**IEEE P802.11  
Wireless LANs**

**Comments received on 802.11b in Letter Ballot 16**

**Date:** January 9, 1999

**Author:** Carl Andren

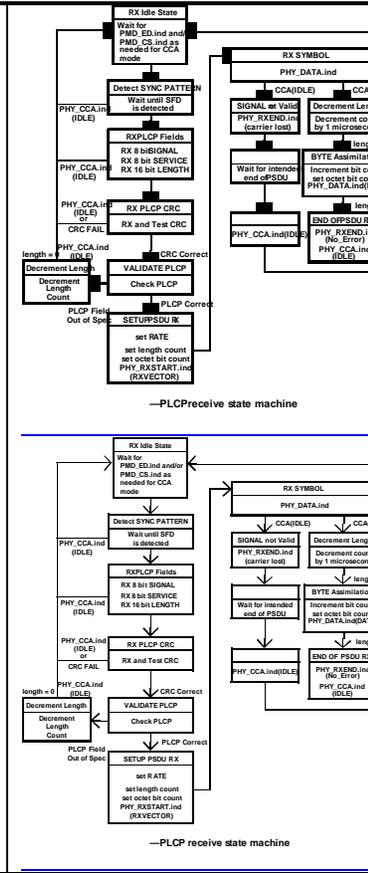
71.	5	1.2.2.2	TT	E		In figure 2, heading for PLCP header is incorrect.	PLCP HEADER 48 BITS @ 2 Mbit/s  should be  short PLCP HEADER 48 BITS @ 2 Mbit/s	<a href="#">ACCEPTED, add "short" to the label. Editor to fix figure.</a> <del><a href="#">ACCEPTED, add "short" to the label</a></del>

72.	6	1.2.2.2	TT	E		Need to add the word PLCP to be unambiguous about which preamble and header we are talking about.	The short <u>PLCP</u> preamble uses the 1 Mbit/s Barker code spreading with DBPSK modulation. The short <u>PLCP</u> header uses the 2 Mbit/s Barker code spreading with DQPSK modulation.	<a href="#">ACCEPTED, add "PLCP" to indicate what header is being referred to.</a> <del><a href="#">ACCEPTED, add "PLCP" to indicate what header is being referred to.</a></del>
